MODEL	REV	CHANGE LIST	Model	CT3/5 MB BOARD	
			Page	FROM	TO
CT3/5 MB 31CT3MB0015 31CT3MB0031	1A	<p>PAGE 2 --- Enable CLK48M from clock generator for the PLL circuit of 7411, and disable the oscillator circuit of PCI7411 PLL.</p> <p>PAGE 3 --- Remove H/W shutdown circuit that supported ADM1032.</p> <p>PAGE 4 --- Use X7R type to replace Y5V type for CPU Decoupling/Bypass capacitor.</p> <p>PAGE 10 --- Add a terminal resistor R706 for -CODE_RST# to improve signal quality.</p> <p>PAGE 11 --- 1. Add a 10K pull-up resistor on MCH_SYNC# for booting. 2. Change the power plane of PCIE_WAKE# from 3VSUS to 3V_S5 to solve system can't turn off issue. 3. Change the power plane of ICH_THRM# and SCI_# from 3VSUS to +3V to reduce leakage.</p> <p>PAGE 12 --- We can also use 5VSUS to instead of 5V_S5 to save cost of MOSFET(A06402).</p> <p>PAGE 15 --- Add a level-shift circuit for EDID interface.</p> <p>PAGE 17 --- 1. Add a off-page and a EMI solution for CLK48M. 2. Remove the reserve resistors (R693~R695) of parallel interface for PCI1510.</p> <p>PAGE 18 --- Remove R696, connect controller and power switch directly .</p> <p>PAGE 19 --- Change R682&amp;R683 value from 56 ohms to 0 ohm cause of BOM err

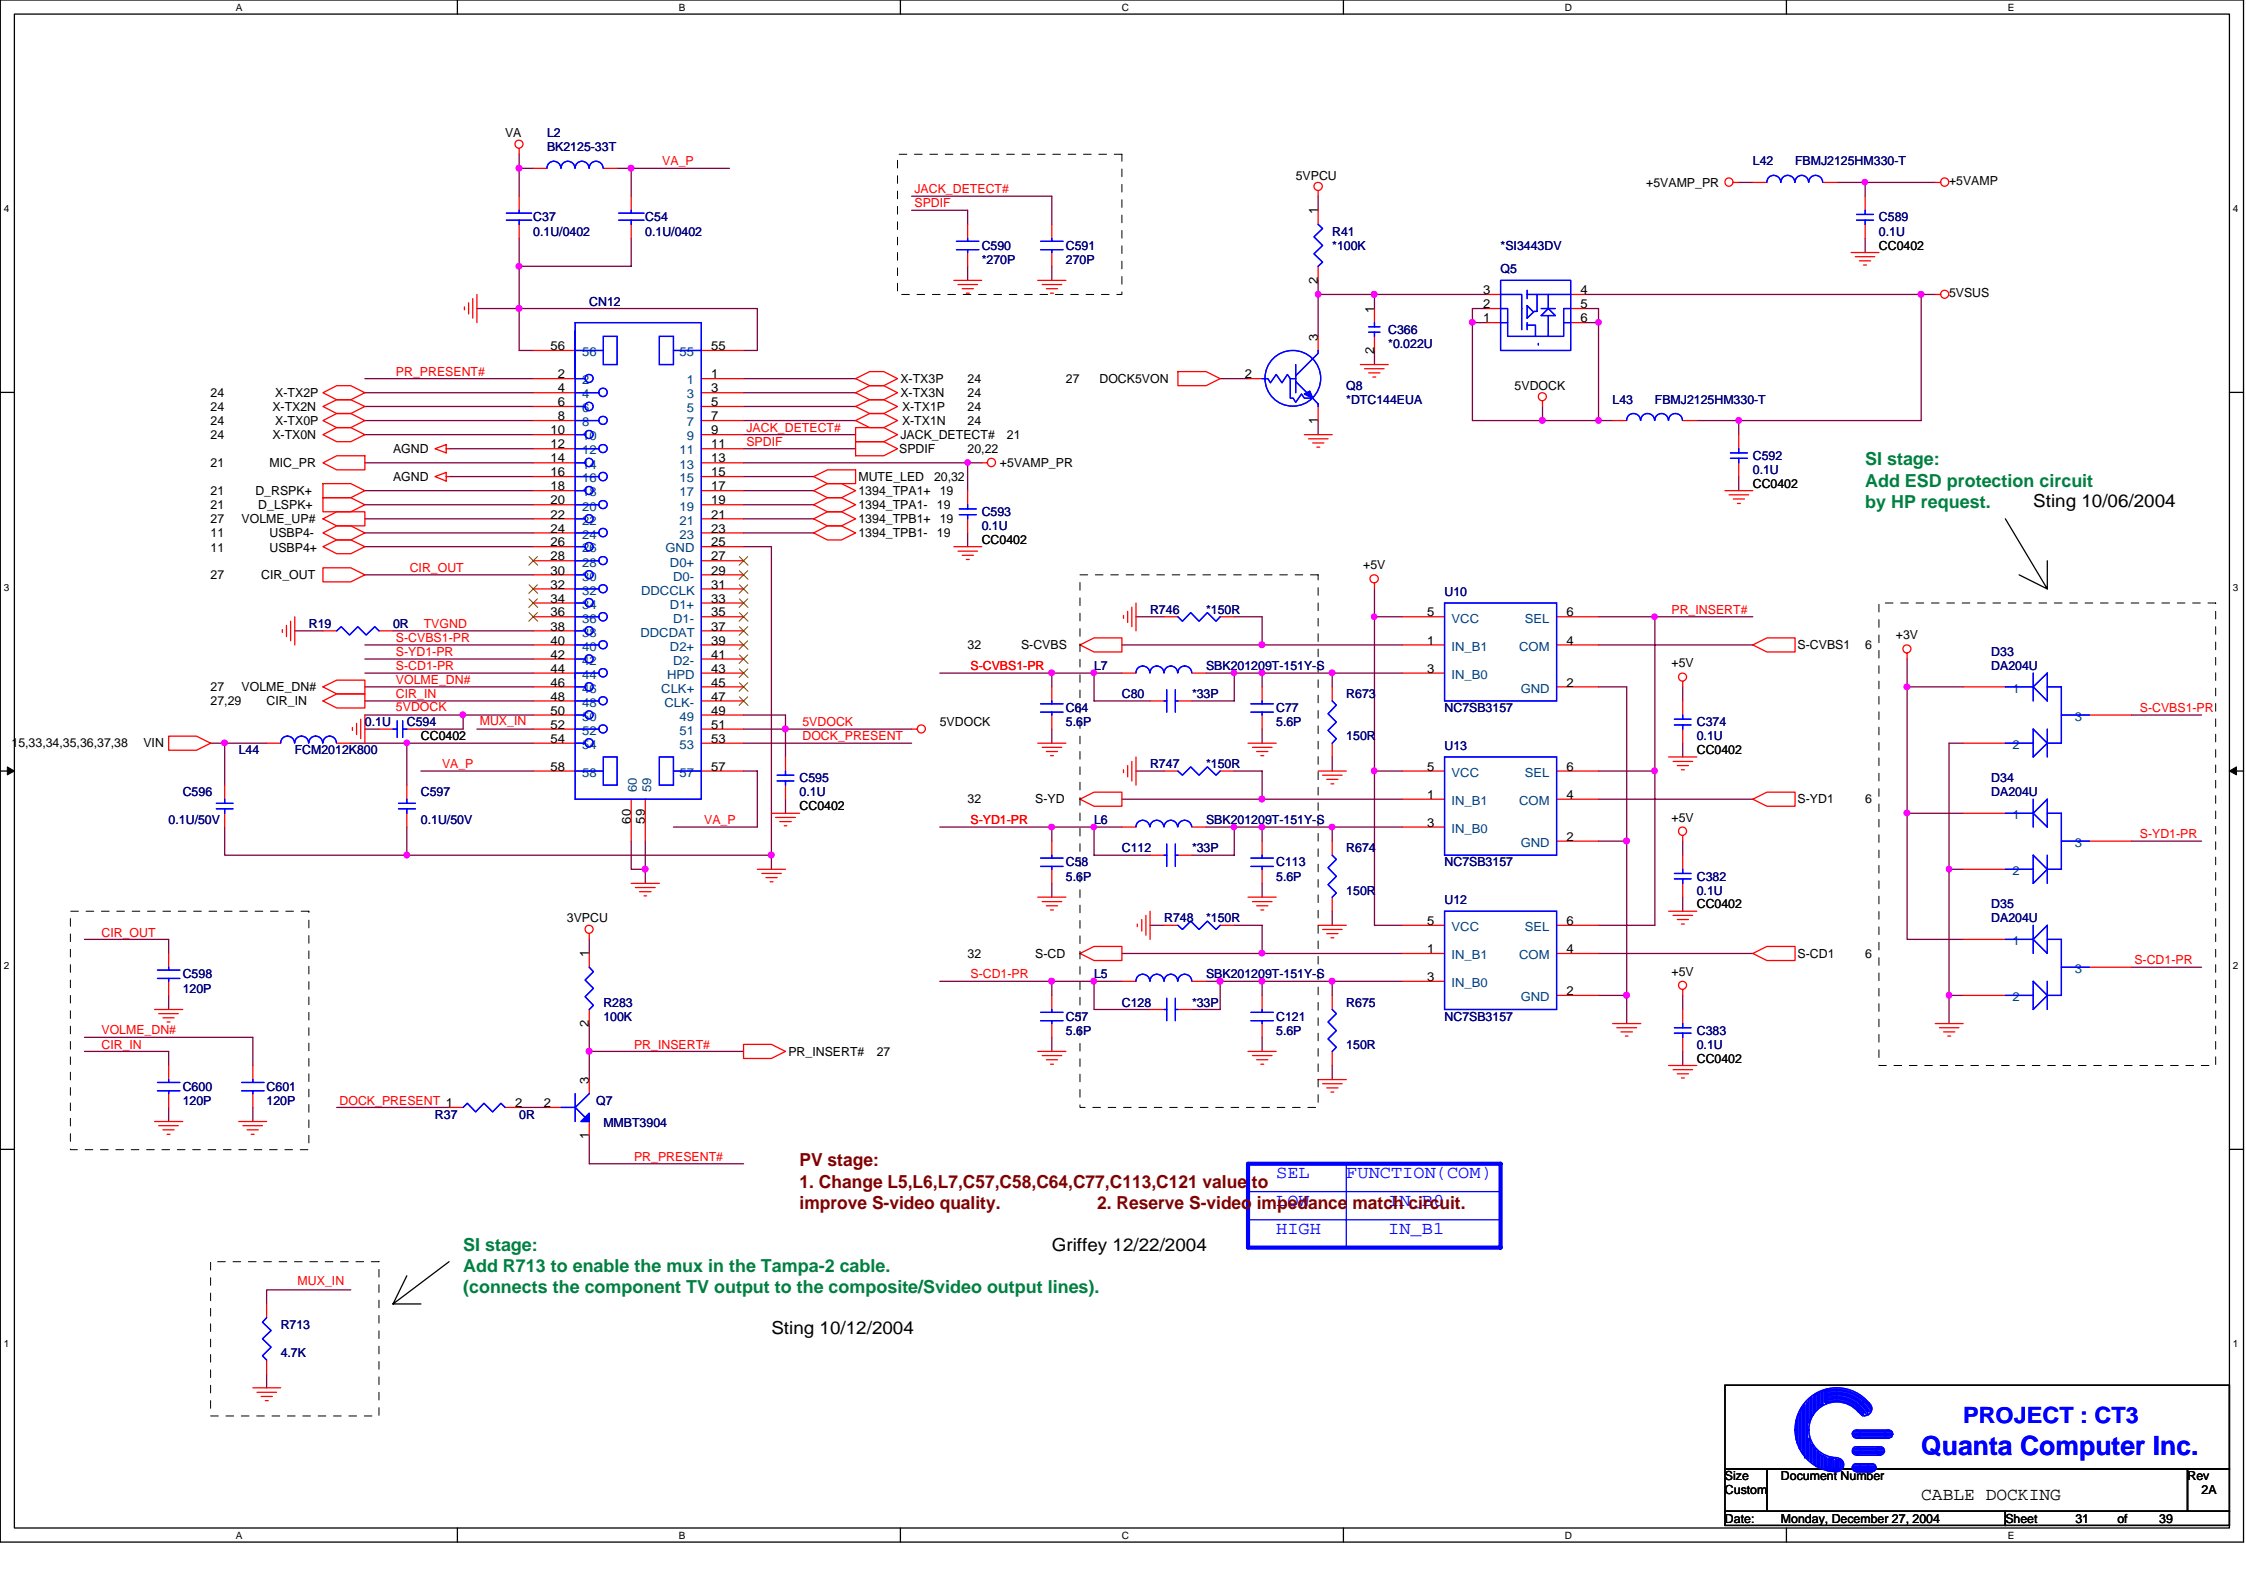
SI stage:  
Add ESD protection circuit  
by HP request. Sting 10/06/2004

PV stage:  
1. Change L5,L6,L7,C57,C58,C64,C77,C113,C121 value to improve S-video quality.  
2. Reserve S-video impedance match circuit.

SI stage:  
Add R713 to enable the mux in the Tampa-2 cable.  
(connects the component TV output to the composite/Svideo output lines).

CPU VCC\_CORE  
(MAX1907)

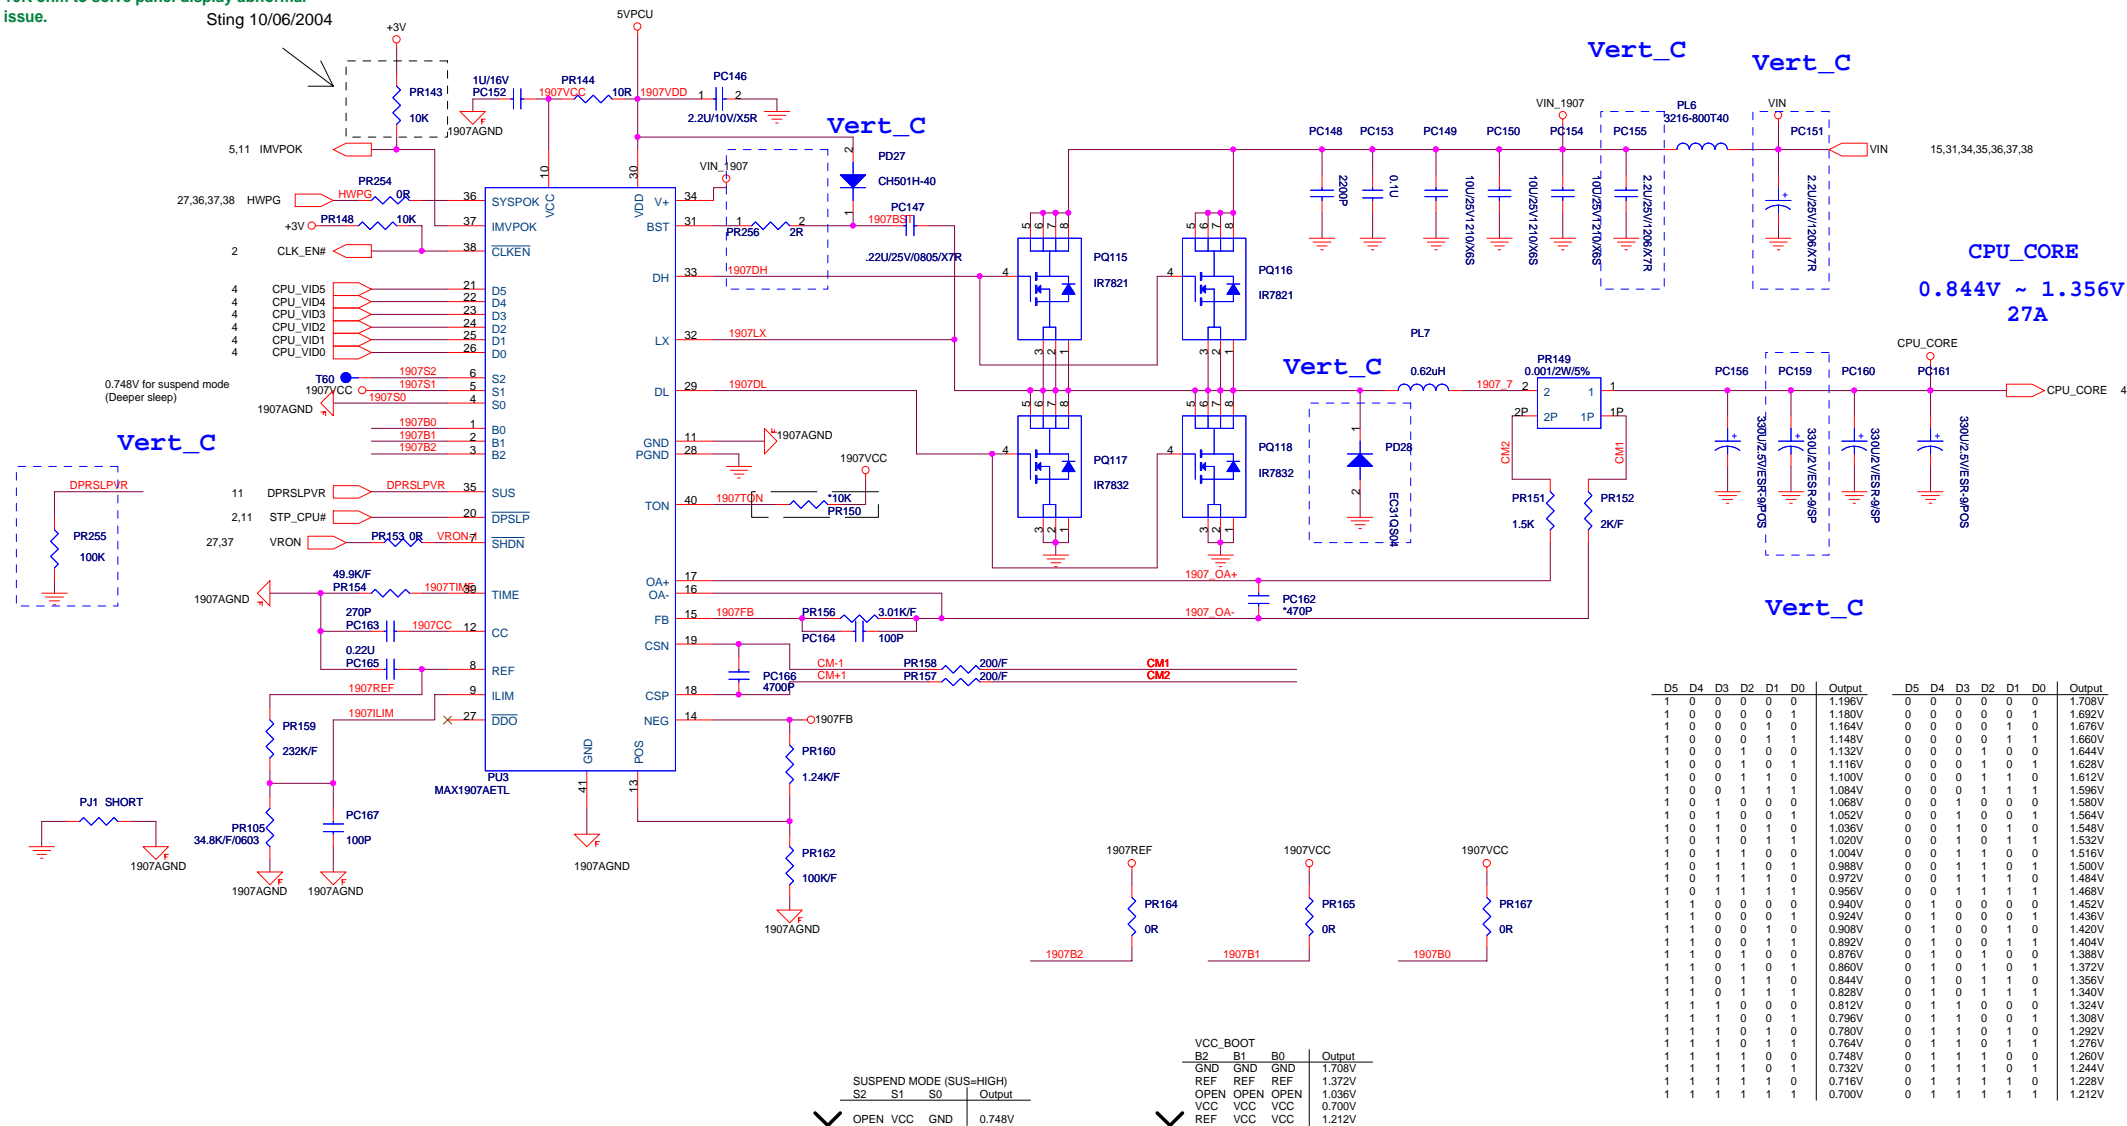
SI stage:  
Change PR143 value from 100K ohms to 10K ohm to solve panel display abnormal issue.

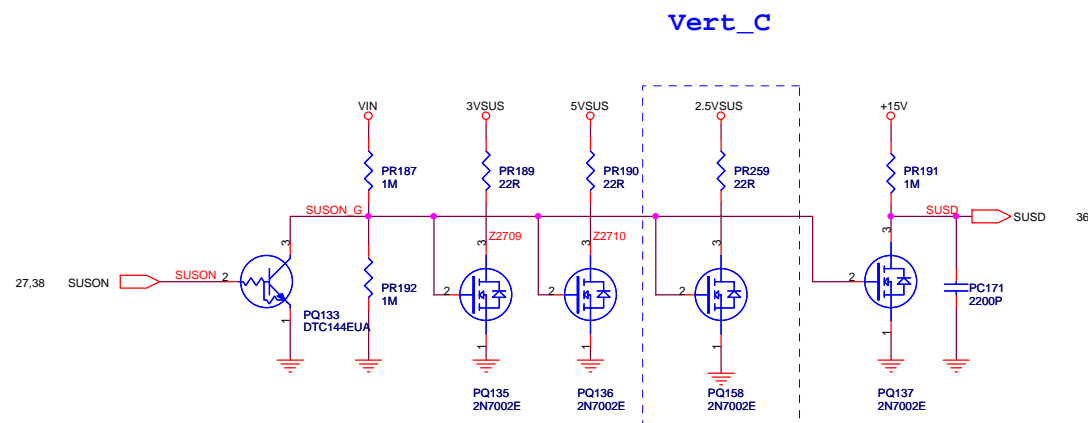
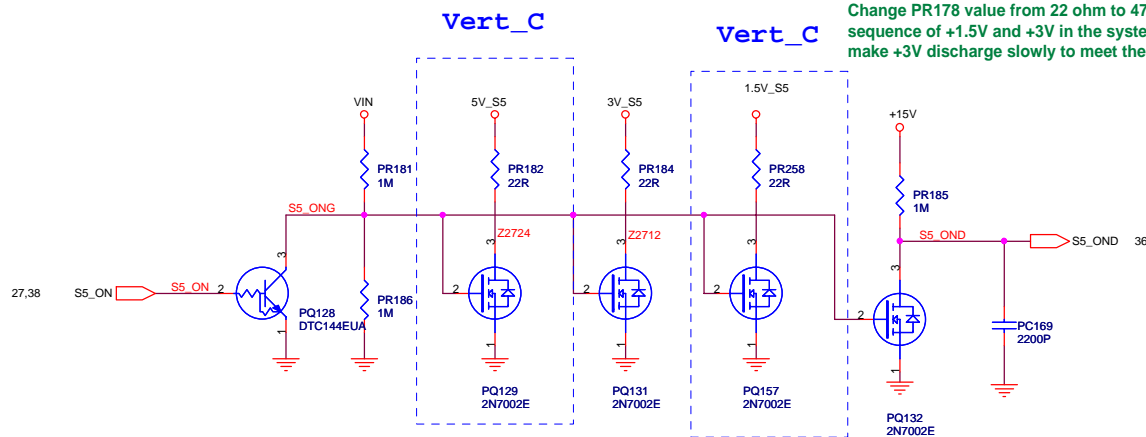
SI stage:  
Change PR178 value from 22 ohm to 47 ohm, Intel has required the timing sequence of +1.5V and +3V in the system, we'd like to increase the value to make +3V discharge slowly to meet the specification of falling time.
